Procurement Department
IFB: Neuberger Museum South West Courtyard
Project SU-111320
Addendum #2 * February 3, 2021

Purchase College Project #SU-111320 Neuberger Museum South West
Courtyard.

Addendum #02 - Bidder's Questions & Answers

Project:
SUNY PURCHASE NEUBERGER MUSEUM SOUTH COURTYARD WATERPROOFING
 Address:
 735 Anderson Hill Road
 Purchase NY 10577

Drawing No.:
C202.01
 Scale: AS NOTED
 Date: 08/24/2020

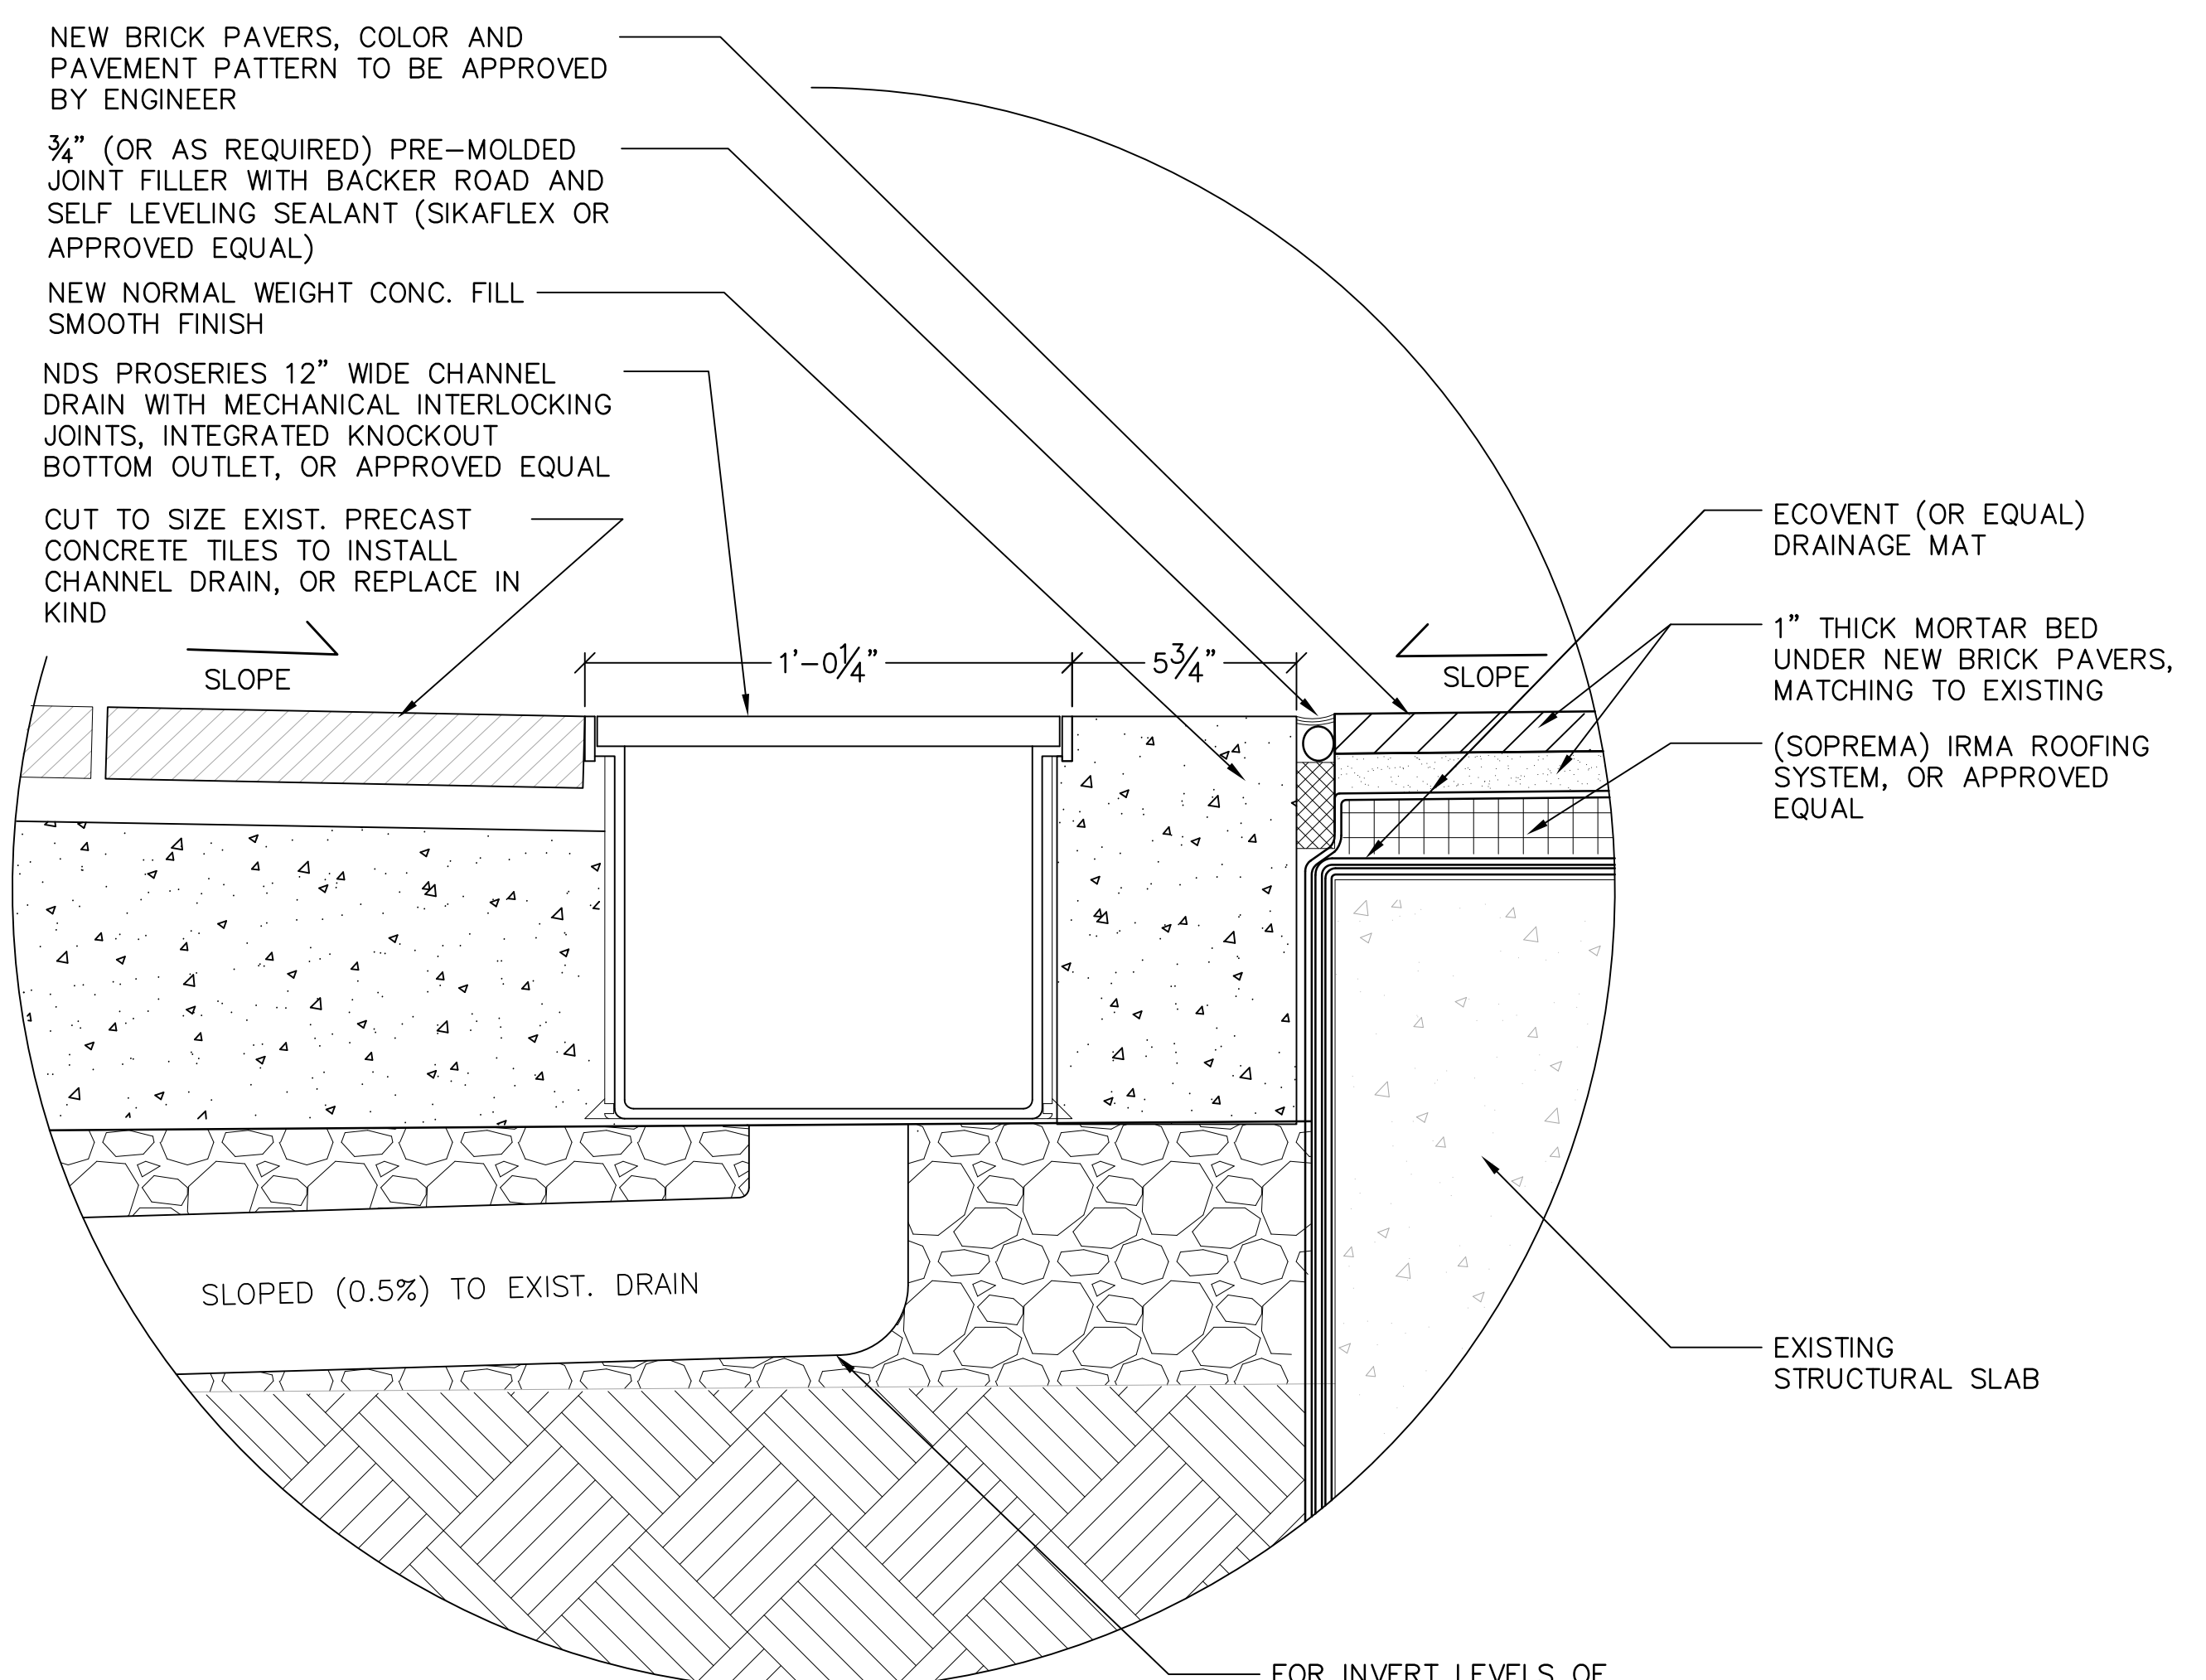
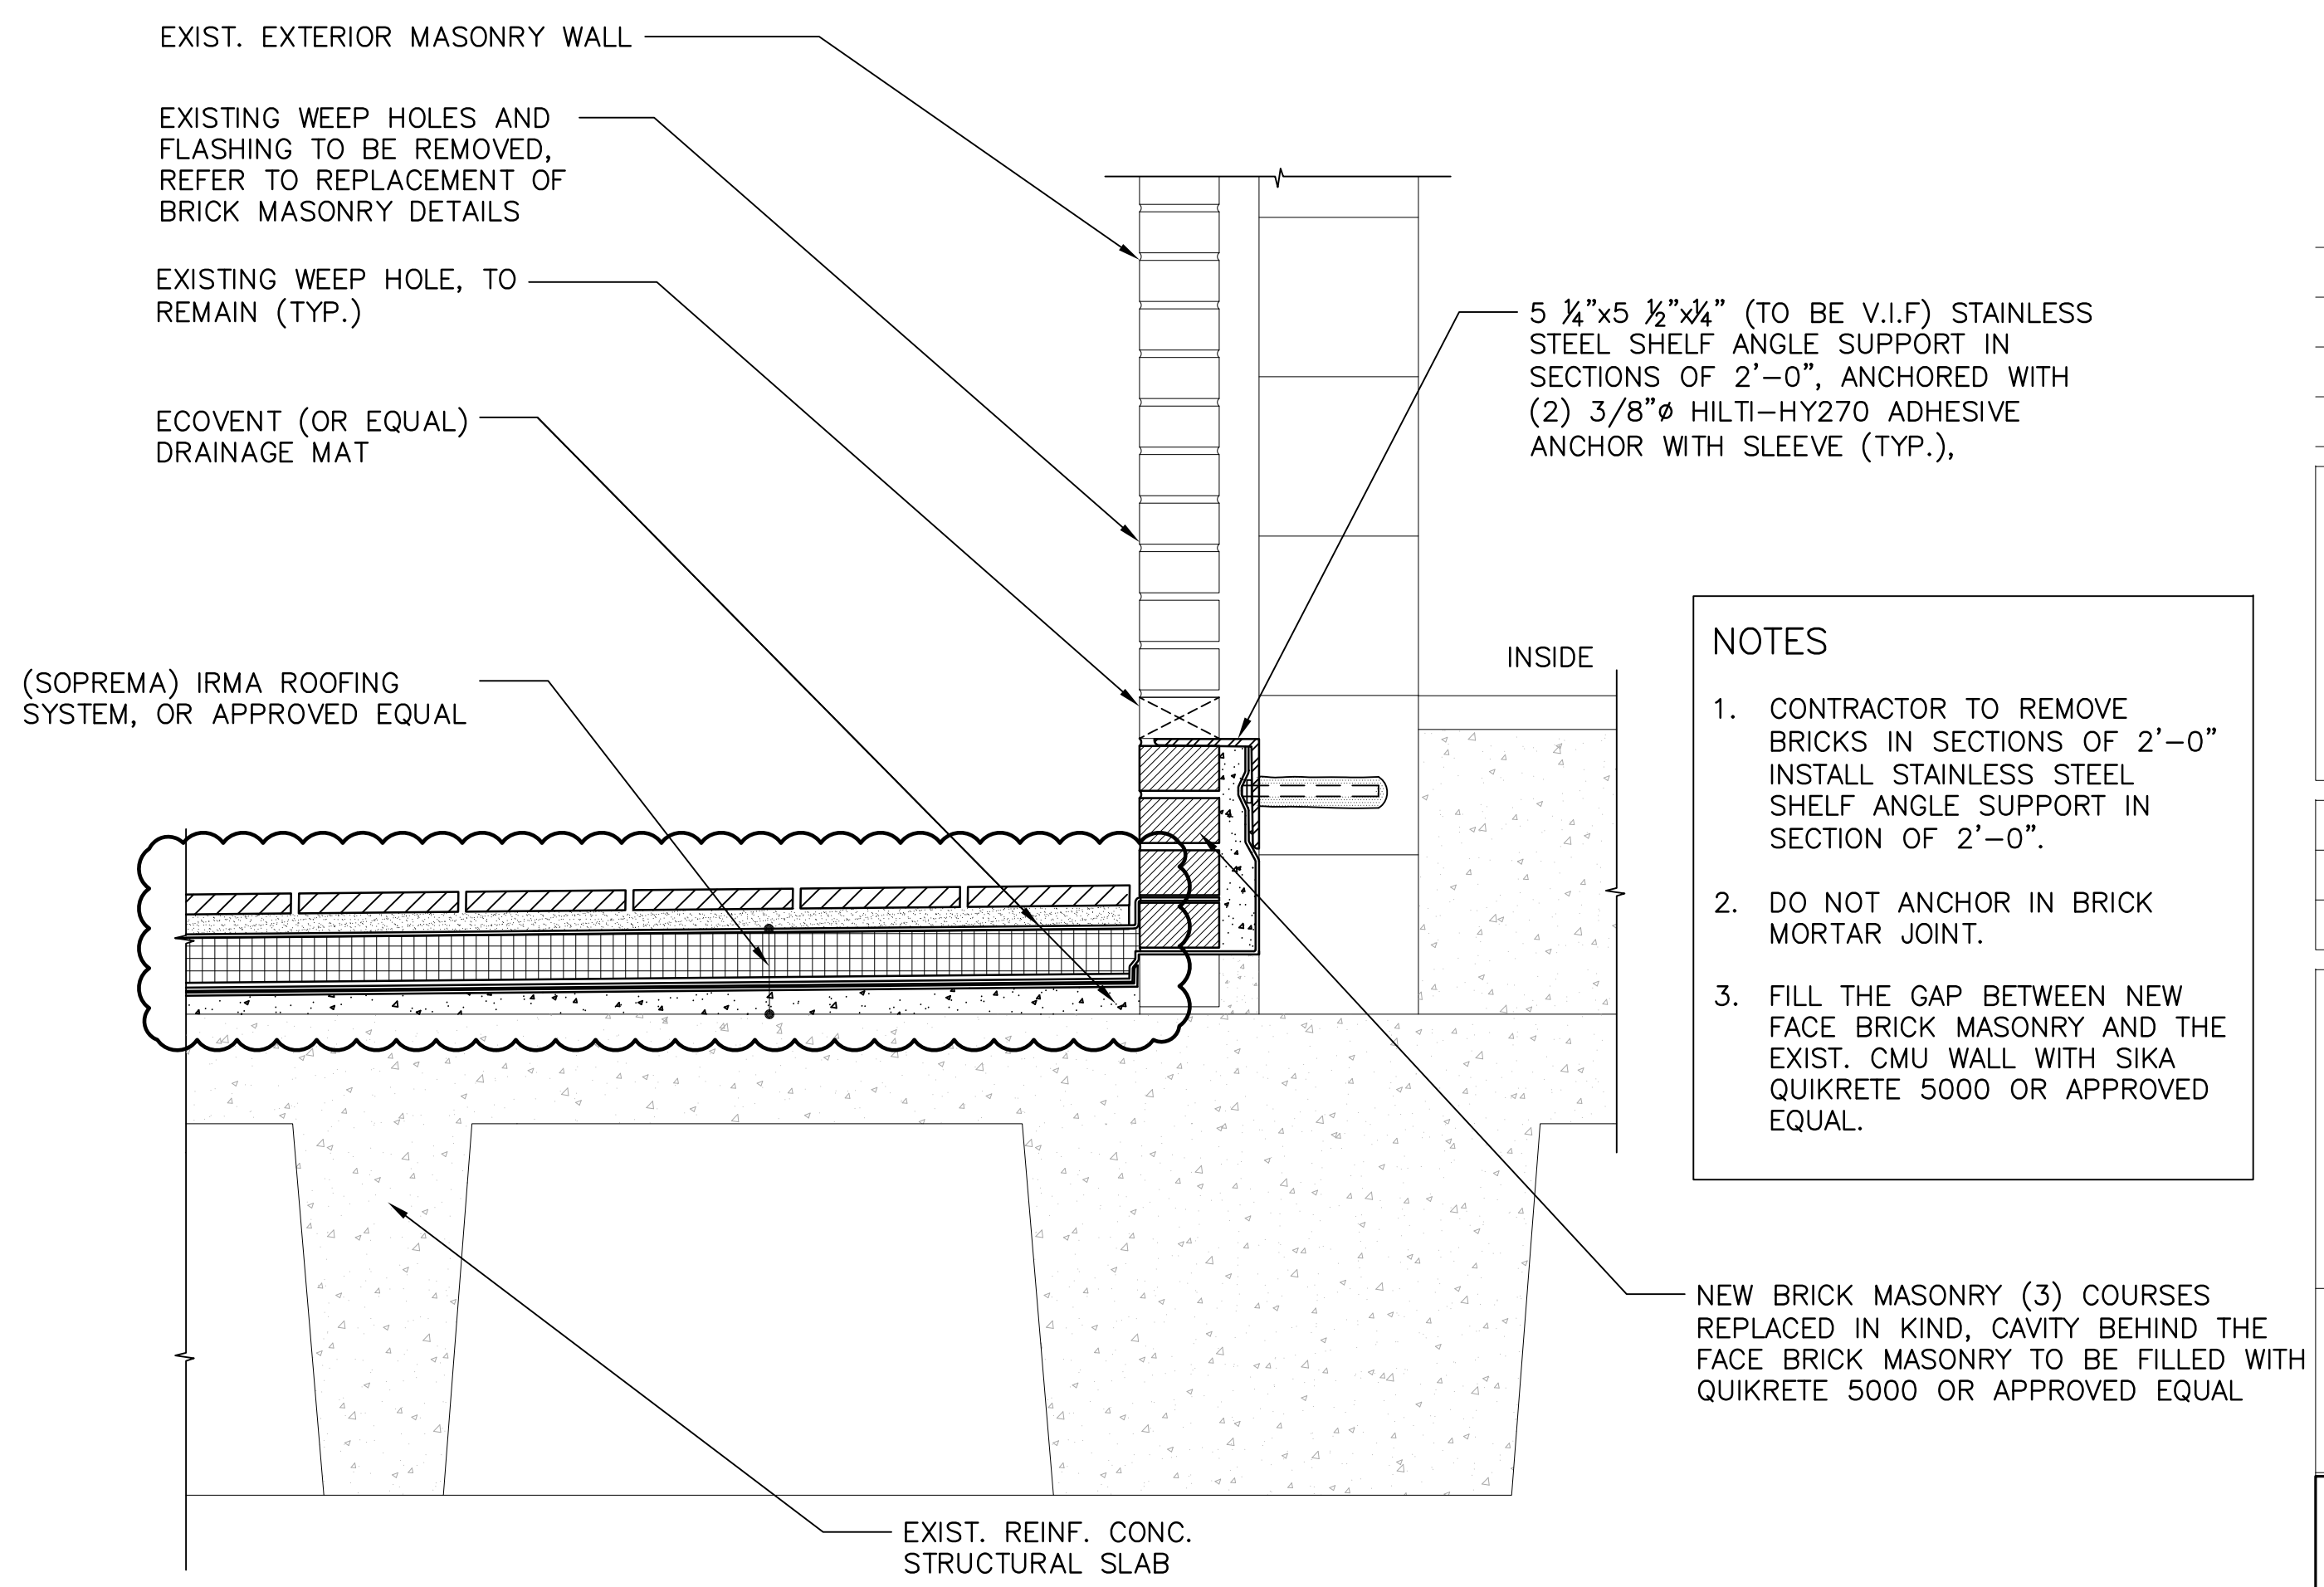
Revised drawing C202.01 supersedes the original drawing C202.00.

- Q1. Are we installing at torch-down, or cold-applied IRAM roof system? Specification 07553 lists both options. The torch-down option would be the most cost effective.

- A1 Refer to revised drawing C202.01. IRMA Roofing system is SOPREMA or approved equivalent.**
- Q2 Specification 07553 lists R30 min, 60 PSI XPS insulation but does not provide a pitch for the tapered system shown on C202. What pitch are we installing for the tapered XPS (1/4" or 1/8")? If we're to match the existing slope looking at C103 taking the measurement of 343.75 to 343.5 over 34.33' is only a 0.2/12 slope. That slope does not exist in tapered insulation. Insulation at ¼" pitch would start at 6" and grow to 8.4" over the 37'10" length per C103. 1/8" would grow from 6" to 7.18". It might be better to pour a pitched LWC topping slab over the existing at the required pitch. This way we can install the IRMA system with flat XPS insulation.

- Q3 Specification 07553 calls for a continuous R30 insulation system and for the new courtyard assembly slope to match existing site levels. The system includes 2-ply Soprema system, ½" drainage mat, 6" start of XPS tapered insulation (R30), filter fabric, min ¾" to 2" max setting bed & 2" thick pavers. Minimum thickness of the system would be 9"-10" +/- . Will this new assembly depth match up to the existing?

- A2 We concur with pouring a light weight concrete screed to pitch for proper drainage and using flat insulation panels. Refer to revised drawing C202.01. Prior to pouring LWC topping coordinate with roofing vendor/contractor.**

- A3 First of all the mortar bed should be one inch with one inch pavers. This reduces the total height from 7" to 8". The existing height has to be field determined and reported to EOR.**
